# 1419 24TH AVENUE

**Project #:** #3032295-EG, 3035044-LU

**Meeting Type:** Recommendation Packet

# SUMMARY OF GUIDANCE

# FACADE AND MATERIALS

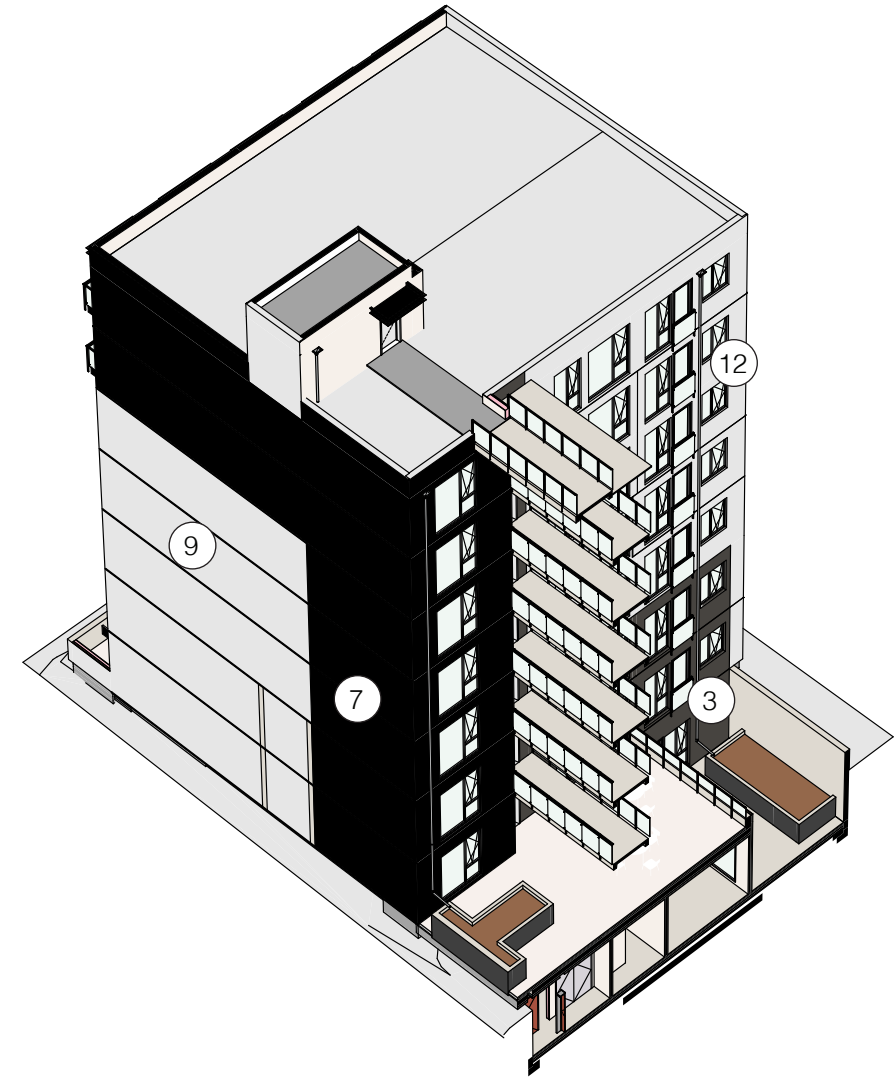
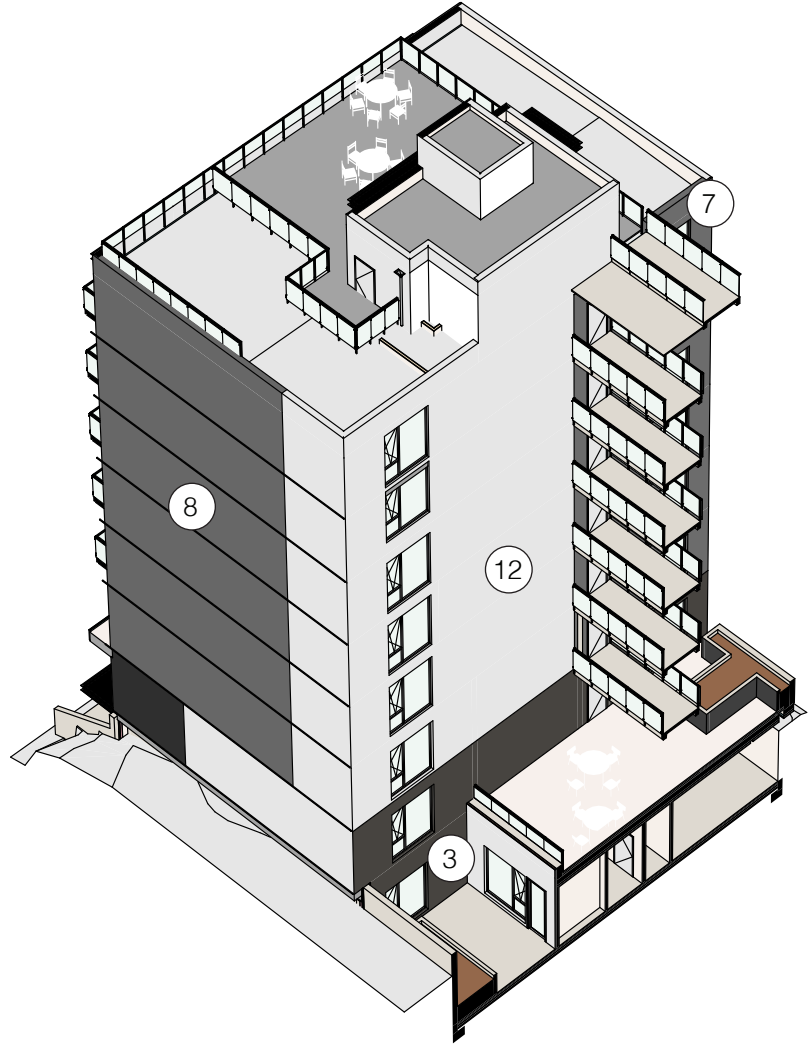
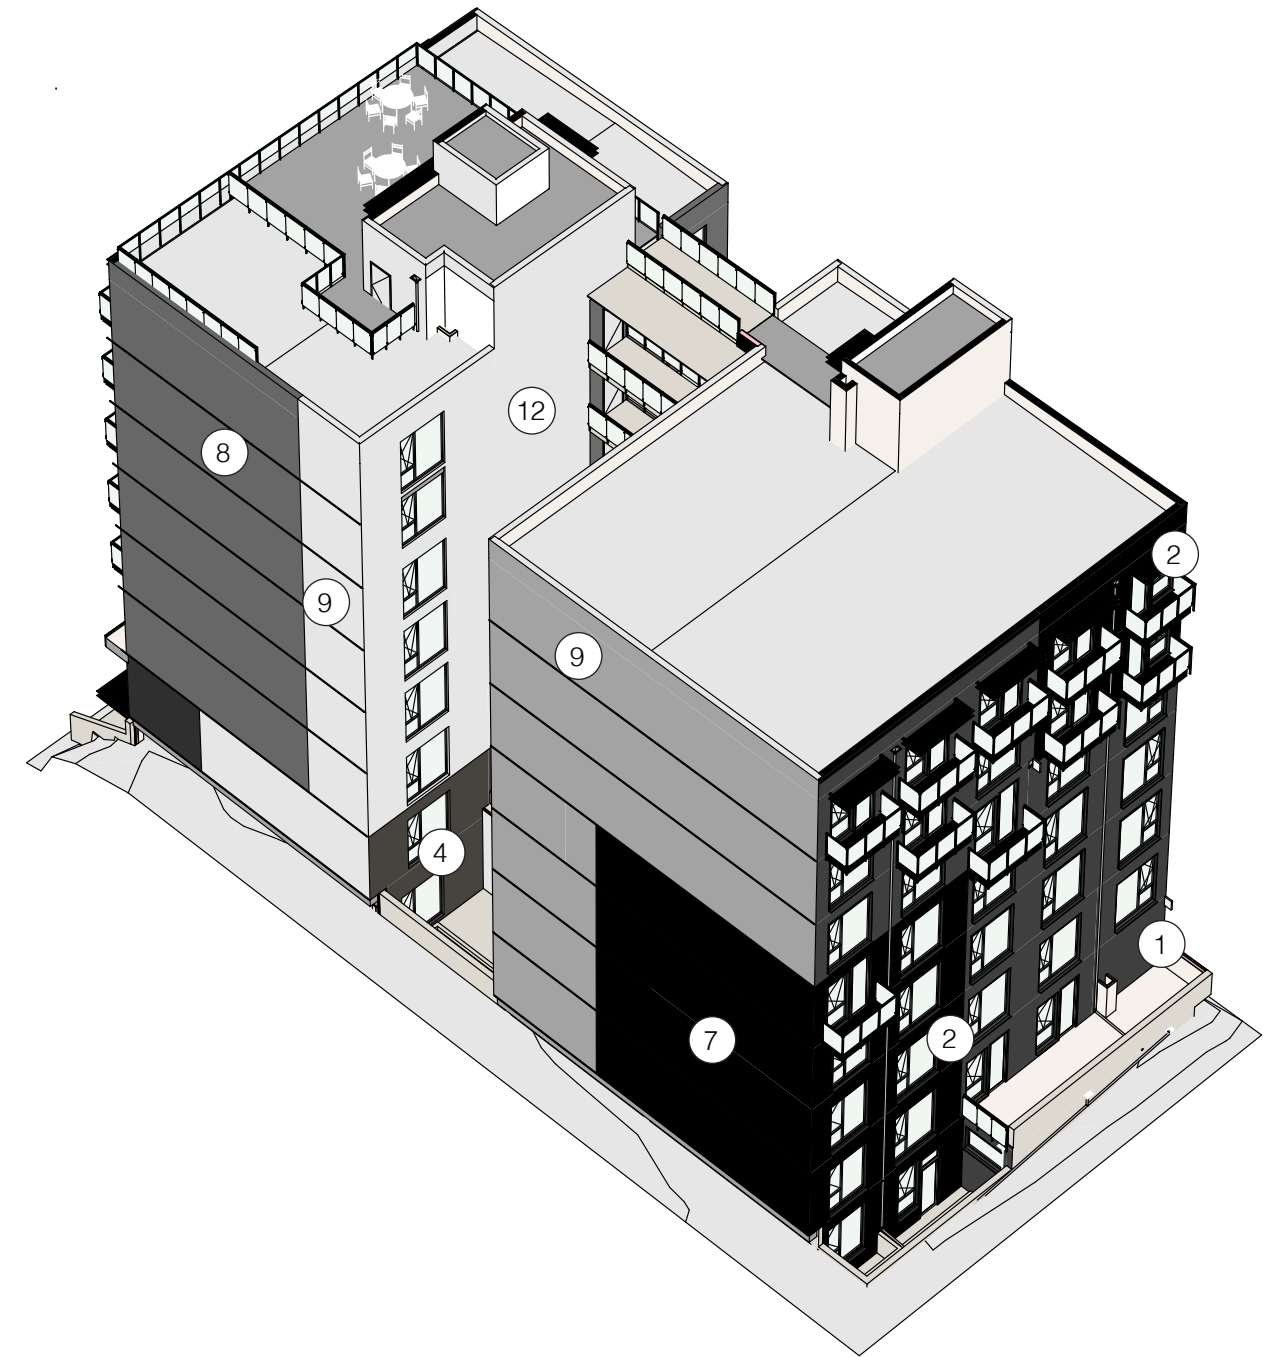
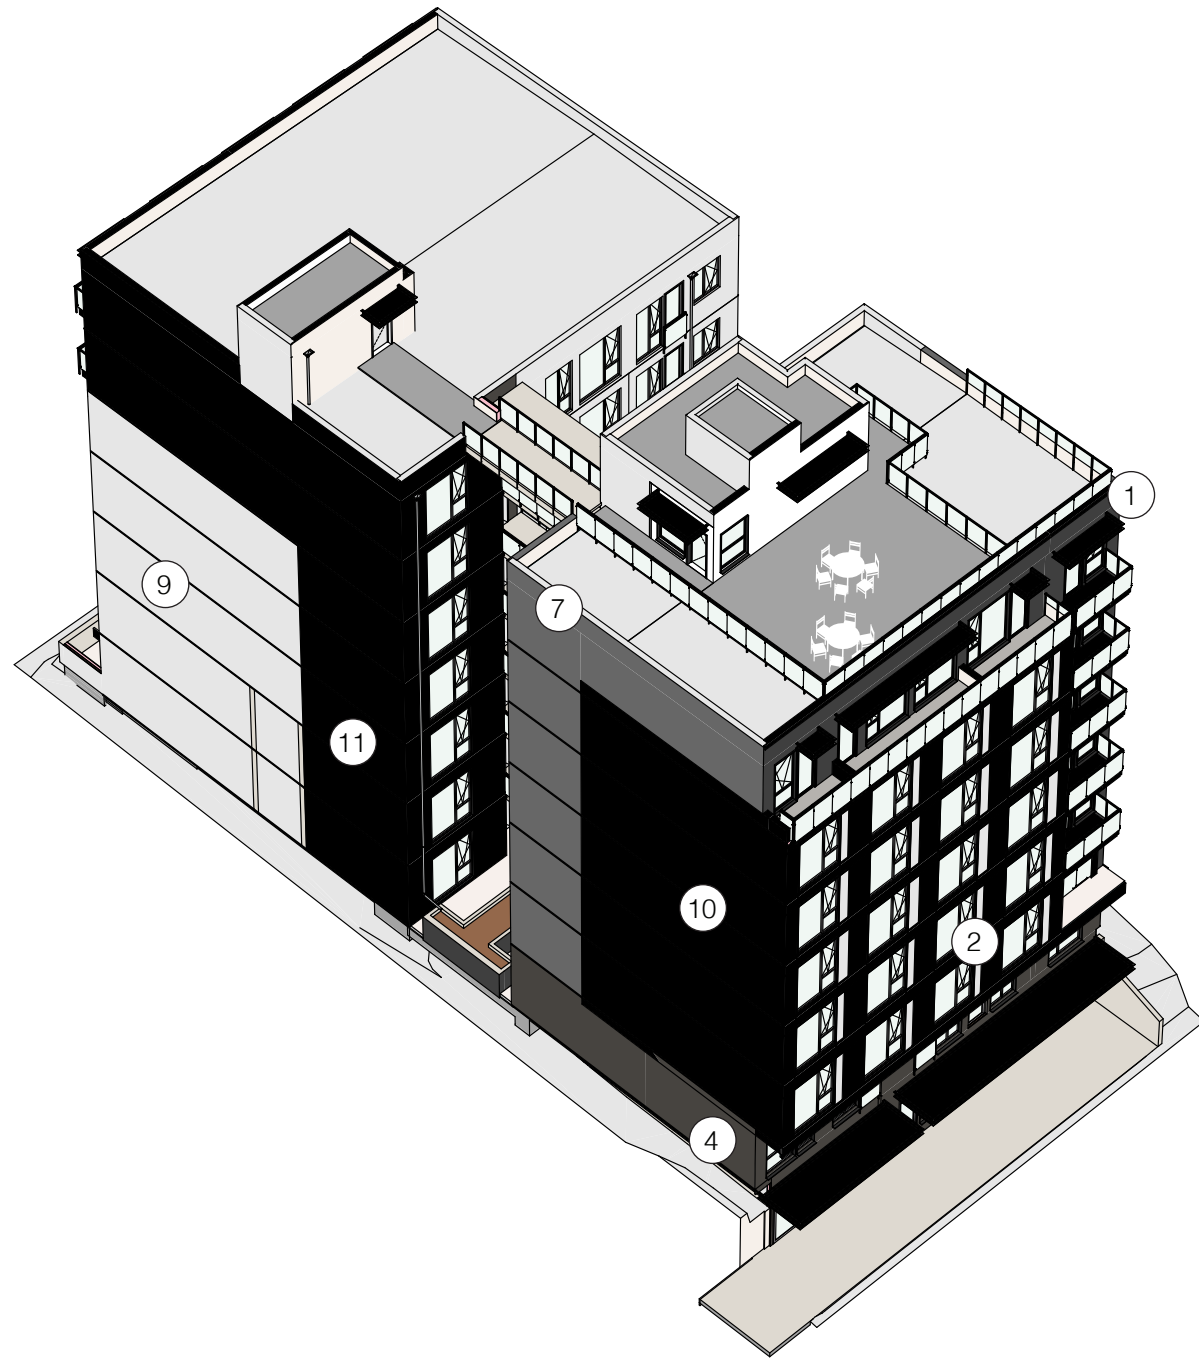
a. The North wall was a point of concern for the Board. They requested that the applicant explore some kind of special treatment here to mitigate its monotony. While they did not wish to explicitly direct the applicant how to mitigate this condition, they suggested it could be tied to the art proposed on site. (DC2-B-2 and DC-2-E-1)

- The north and south facades have been redesigned. The dark panels have been removed and are replaced with larger areas of siding that are more consistent with the treatment of the front and rear facades. These tones turn the corner to the side facades from the front and rear and are legible as massing elements. They also turn into the courtyard.
- The north and south facades have been treated consistently per the comments above. These design elements create smaller volumes on the blank walls. The preferred massing alternative provided two “smaller” building walls in response to the adjacency to the neighboring structures at both sides.
- The black frames have been removed. See response above under “More Critical” for relationship between the facades and larger massing expressions consistent with the street facade on all facades.
